Proposed New Stor-All Building

910 South Dixie Highway, Hollywood, FL. 33020

Below is the required narrative as a response to the comments made at the Preliminary TAC submittal and review. The comment is listed as provided followed by the response in bold.

SUBJECT: Site Plan Review for an approximate 122,970 sq. ft. self-storage facility (Stor-All Storage)

ROOF PLAN

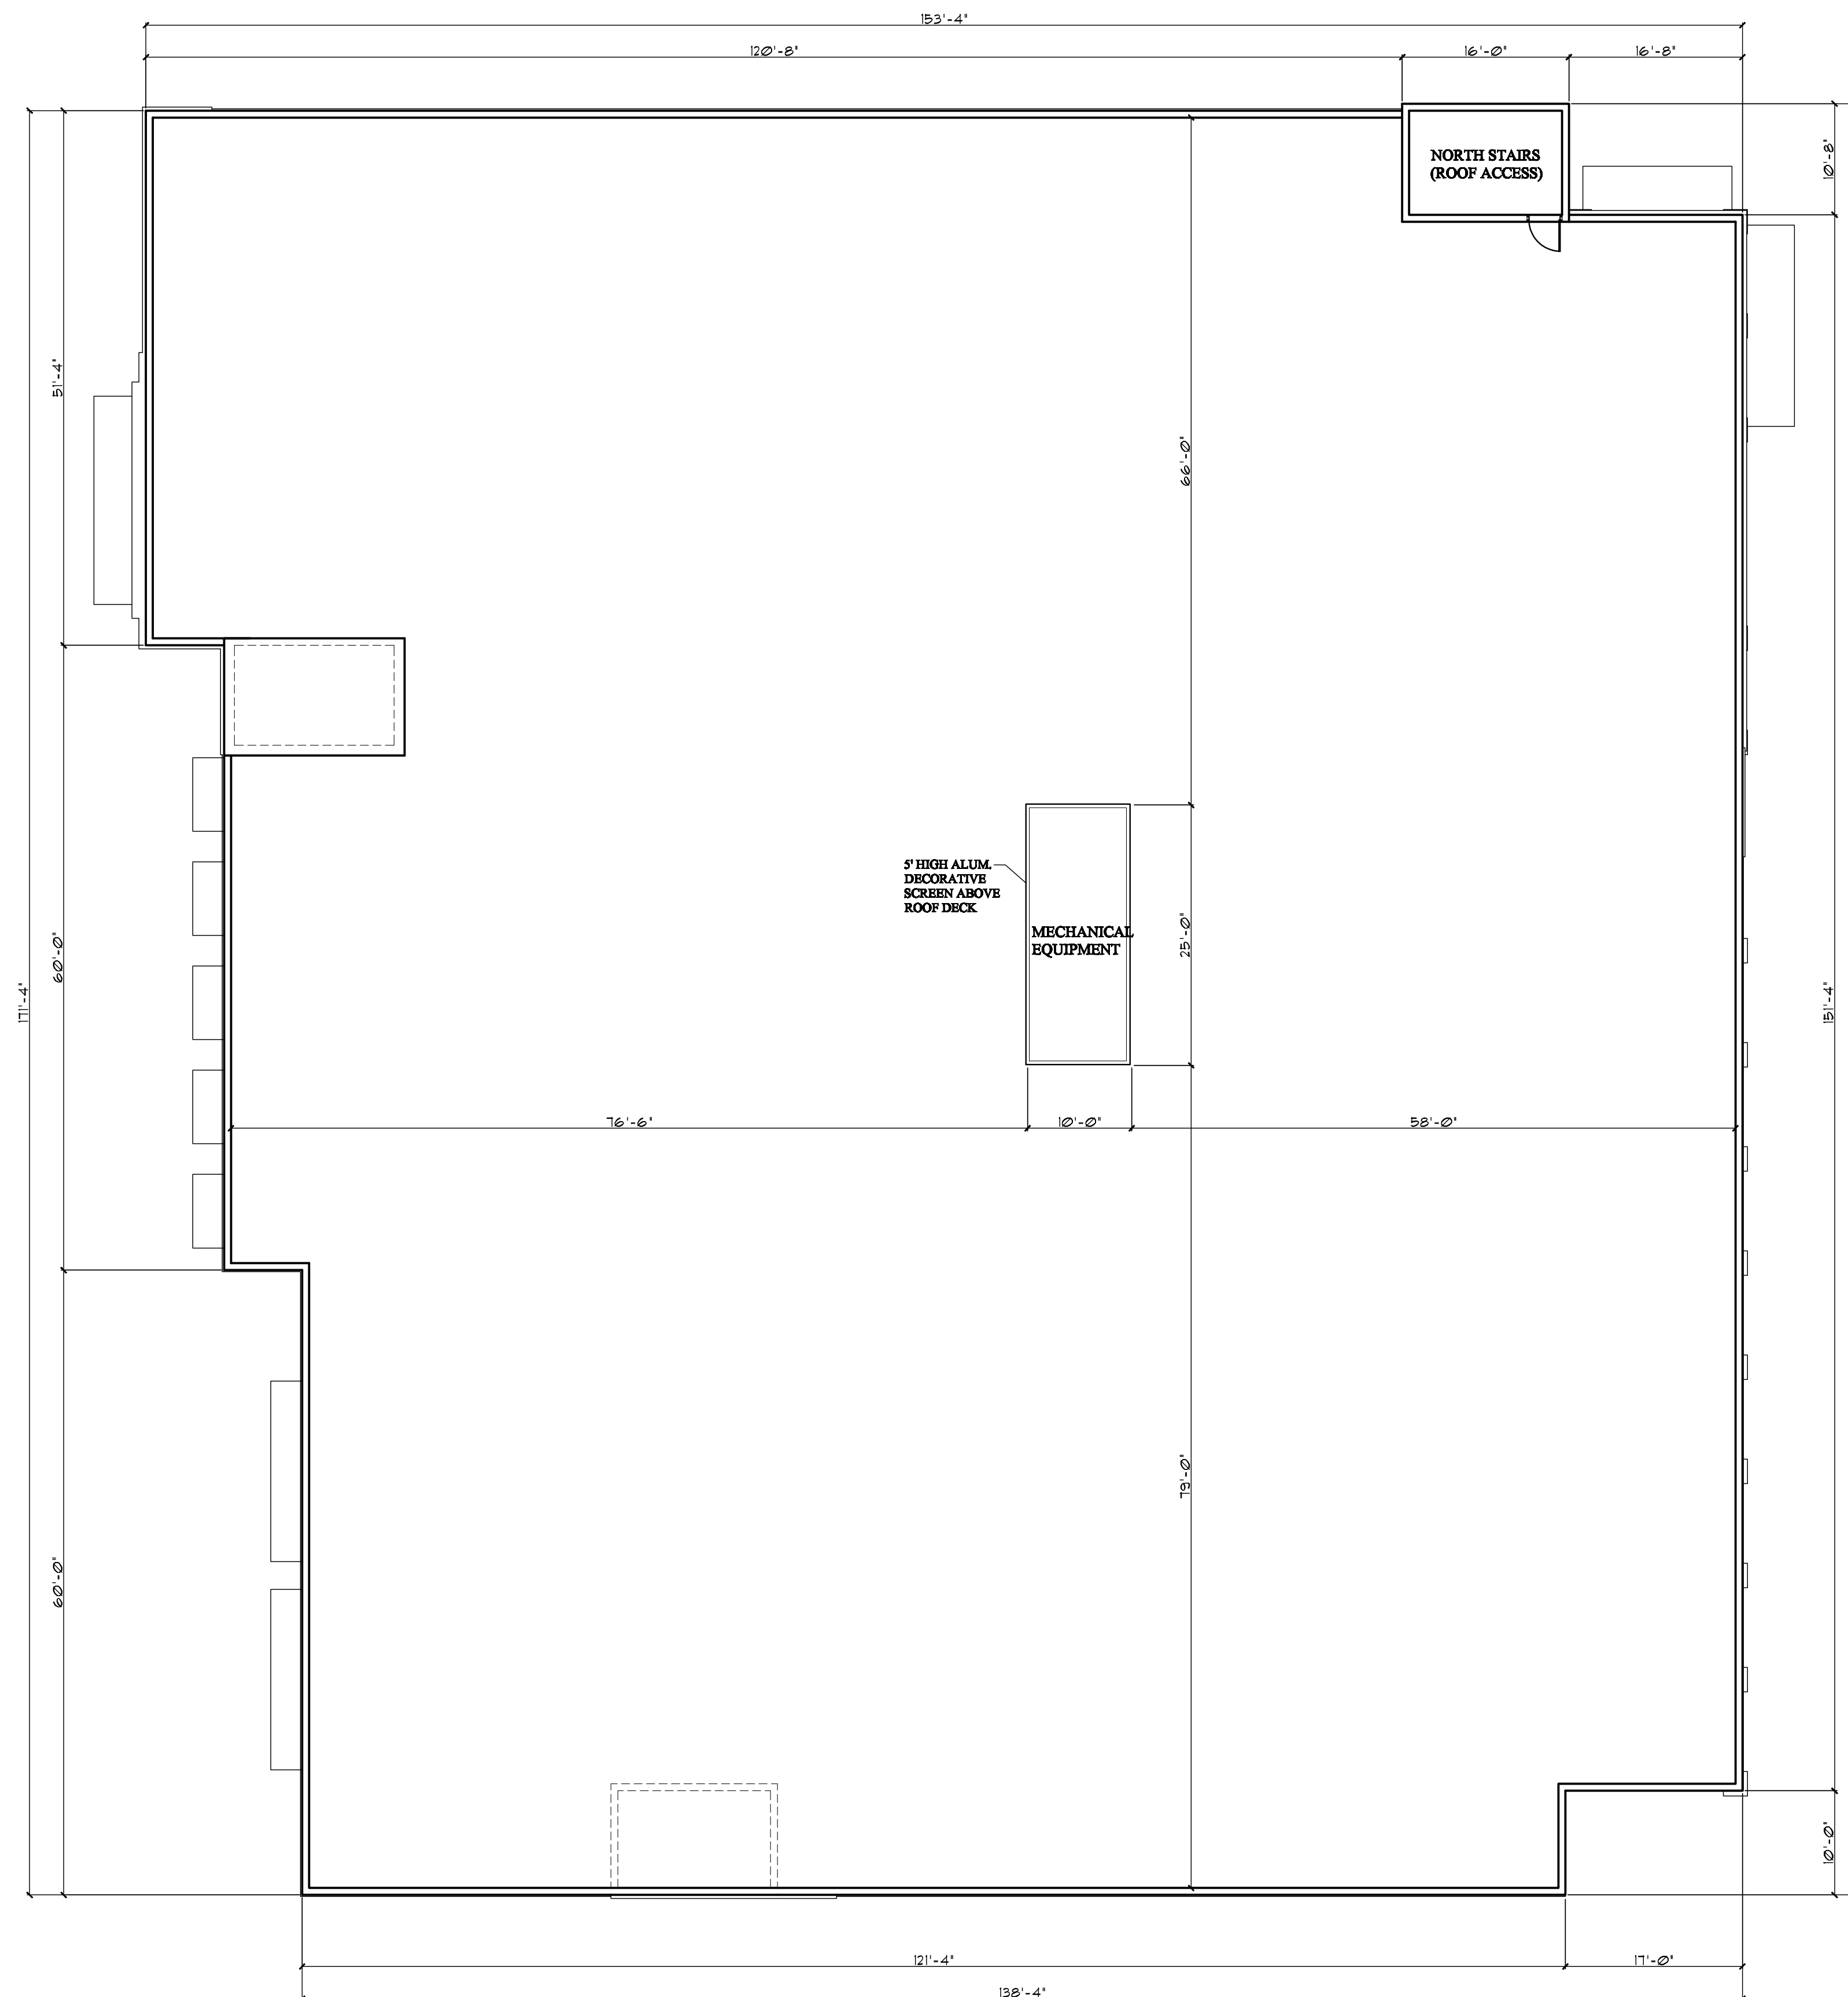
3. Roof plan not included in the submittal. Is there stair access to maintain mechanical equipment?

Yes , Please See New Drawing A-6.

MECHANICAL EQUIPMENT ARE LOCATED ON THE ROOF (SEE SHEET A-6), AND THE ACCESS IS THRU THE NORTH STAIRS

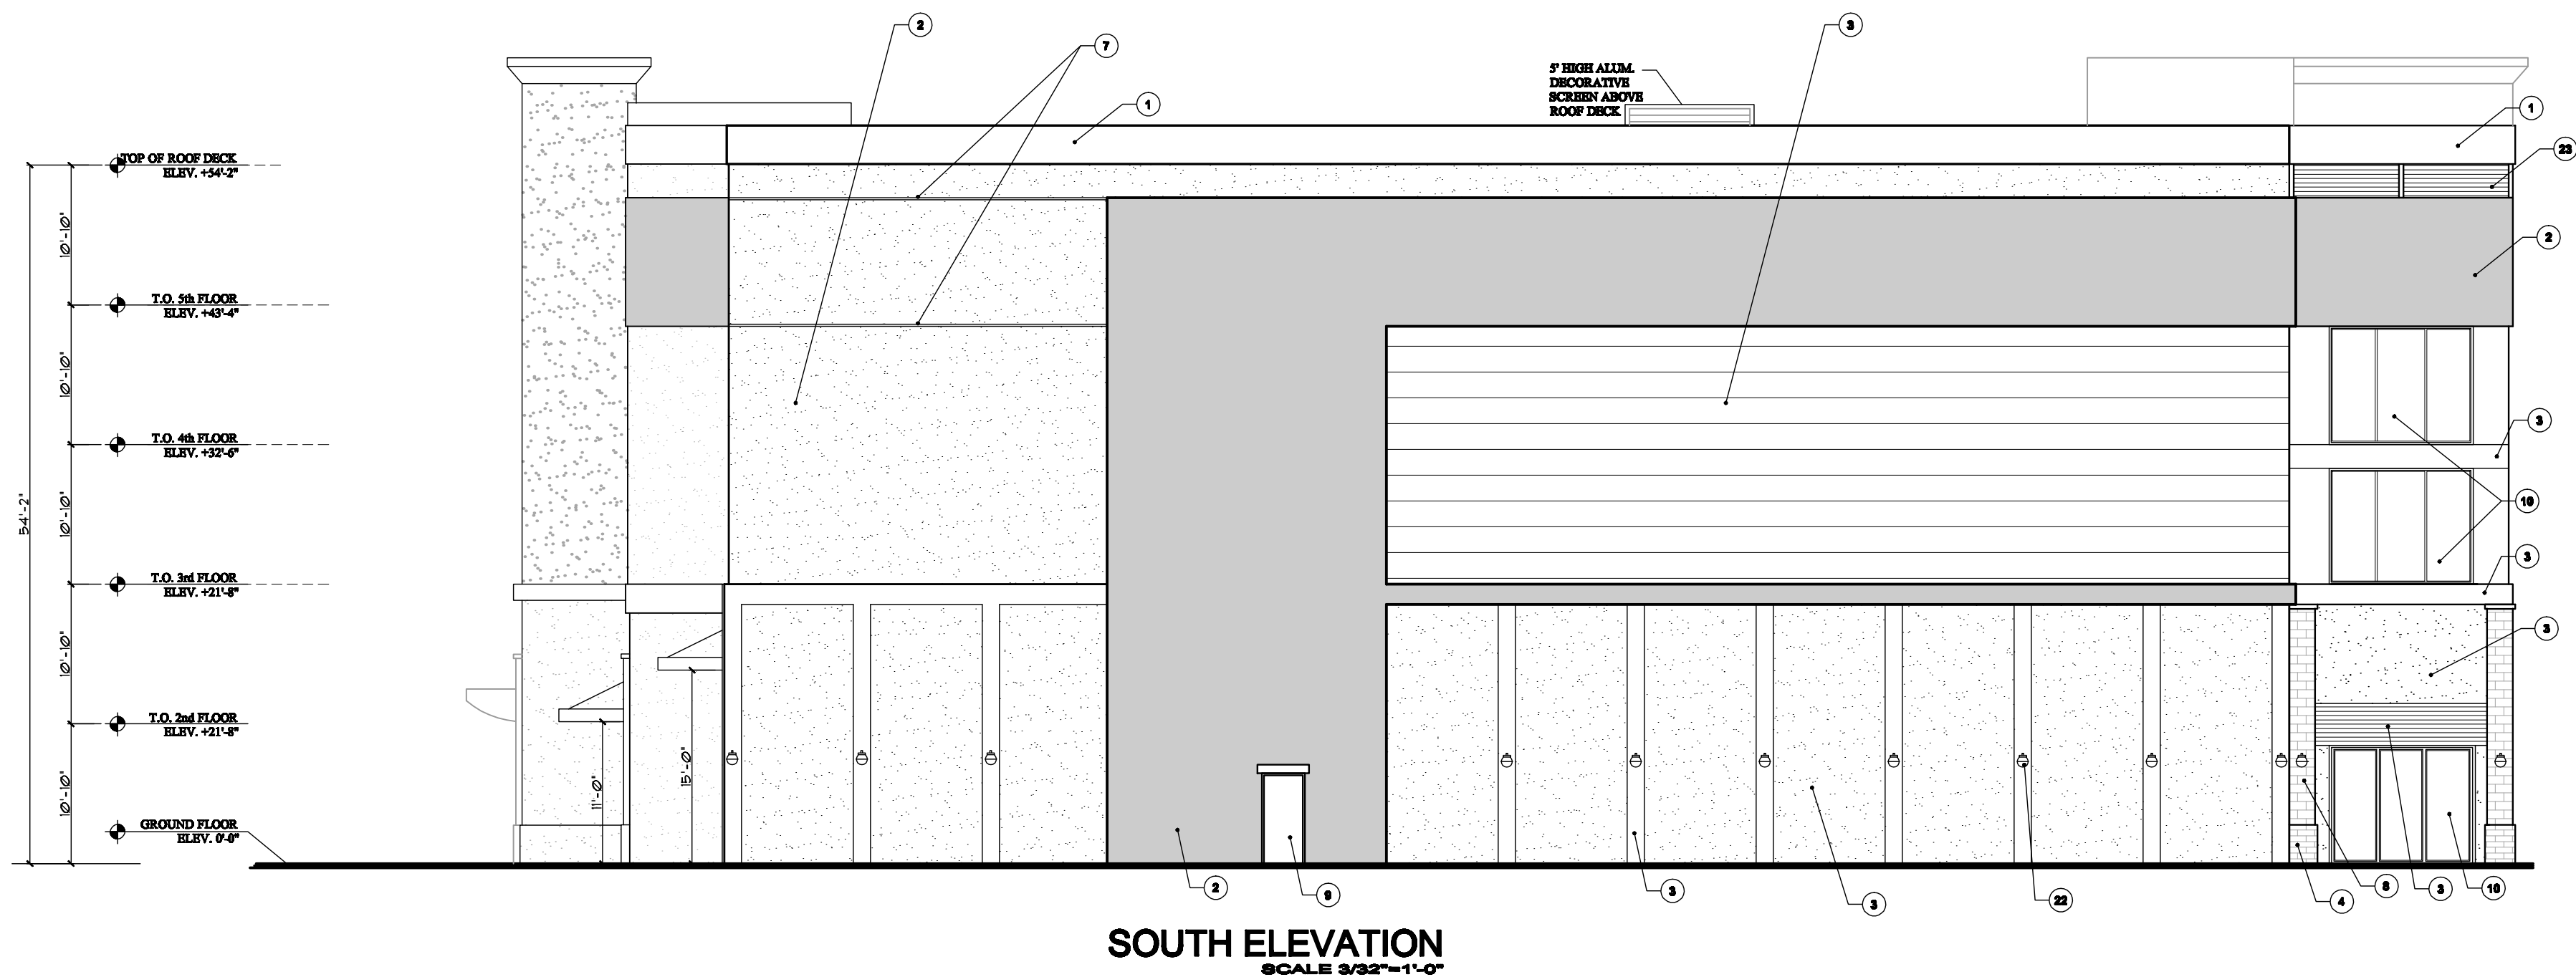
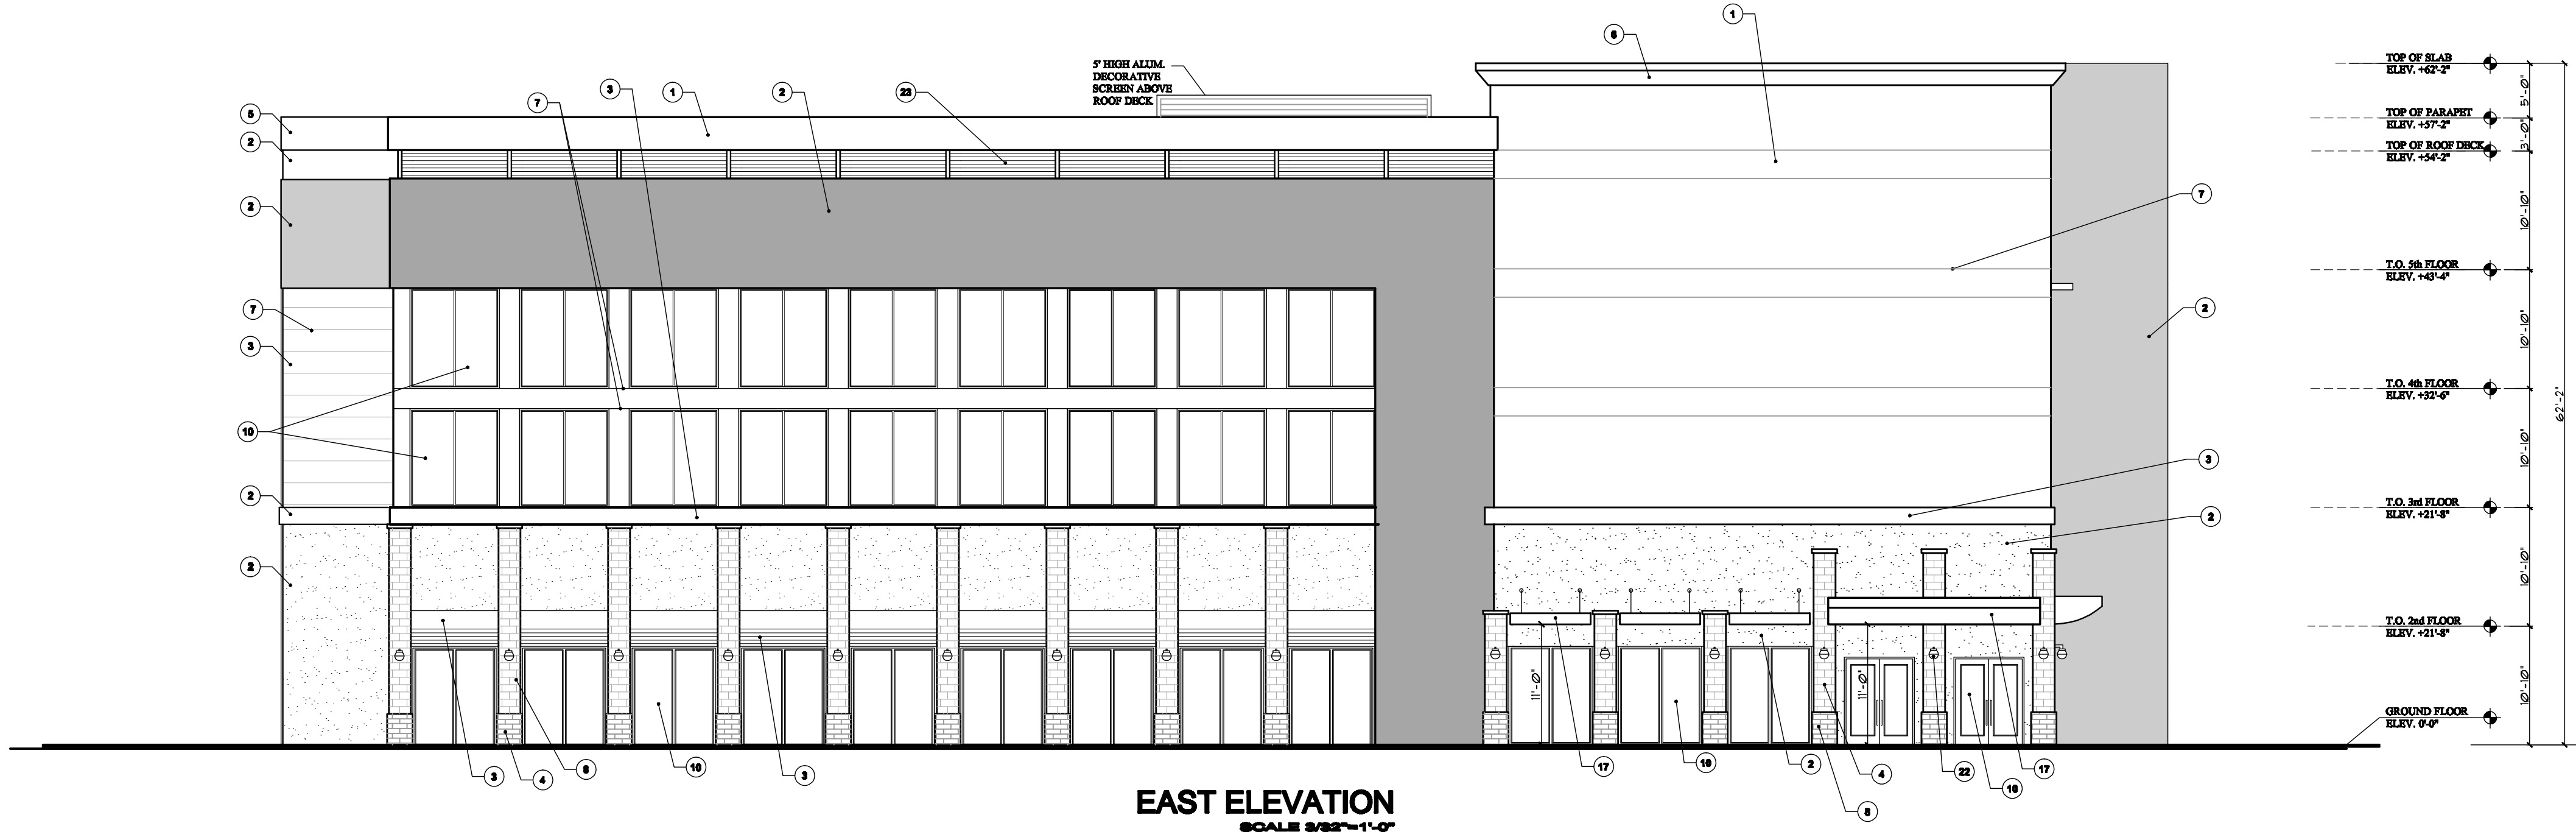
- 11. Revise the following on Elevations:
 - a. Provide materials legend indicating all materials.
 - b. Provide elevation markers on East Elevation.
 - c. Provide diagram indicating compliance with active use and transparency requirements.
 - d. Provide location and dimensions of all building projections (i.e. mechanical equipment). All mechanical equipment shall be screened.

1. Sheet A-4/5: Exterior Elevations – No materials or finishes are called out on the plans.

1. For review, full signage package shall be provided, including signage details, signs illustrated on Elevations, dimensions on Site Plan, etc.

See Revised Drawings A-7 and A-8.

See Revised Drawings A-7 and A-8.

Signage Package Not Included At This Time. Please See, " Signage Shall Be In Compliance Note" On Revised Drawings A-7 and A-8.
